DESIGN REVIEW BOARD

DRB2013-12

Requested Action

Design review for construction of a concealed telecommunication facility

1 LANDSCAPING AND IRRIGATION PLAN

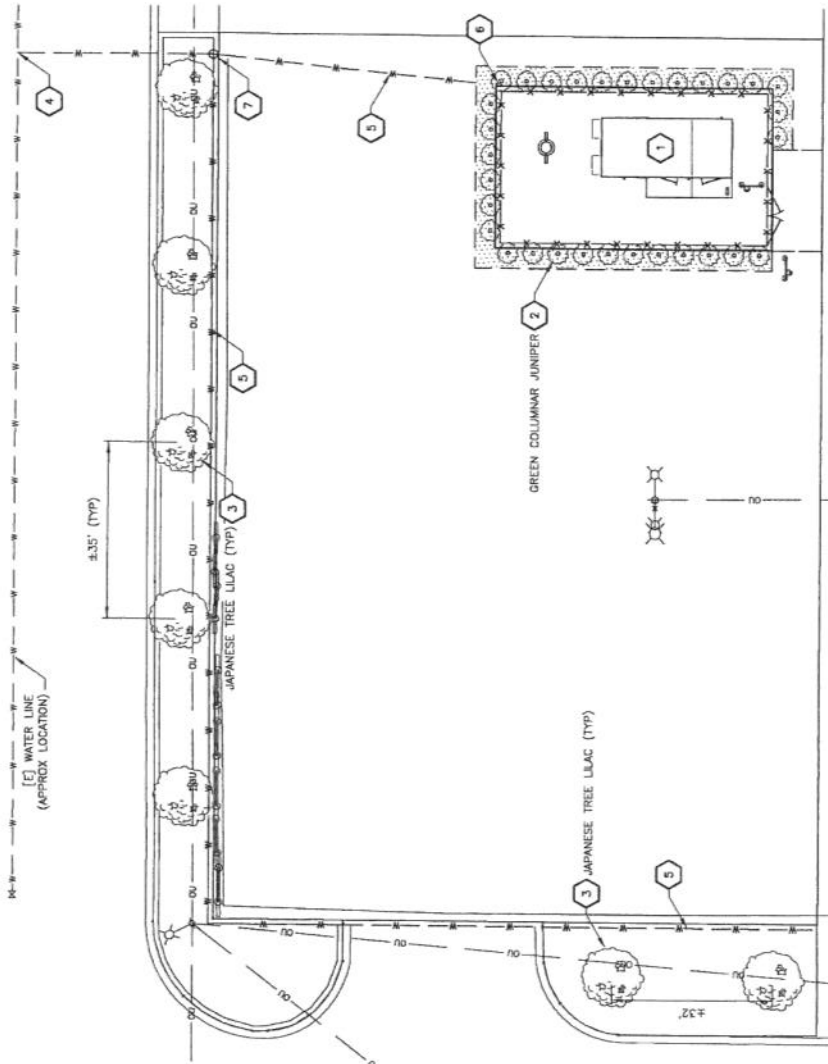
- D. The owner and applicant shall consult with landscape design professionals to develop and install irrigation and sod within the project area of Lots 6 & 7, Block 16, Lincoln Heights Addition, all surrounding the telecommunication facility.

- E. The owner and applicant shall install a second variety of tree between every third Japanese lilac in the boulevard.
- F. The owner and applicant shall install irrigation, sod and two trees in the northern and side areas within the 6,000 s.f. portion of the project area (Exhibit B - Site Plan).

- G. The owner and applicant shall submit a planting plan of the boulevard trees so that future development can install public sidewalks along 12th Avenue South and 24th Street South.
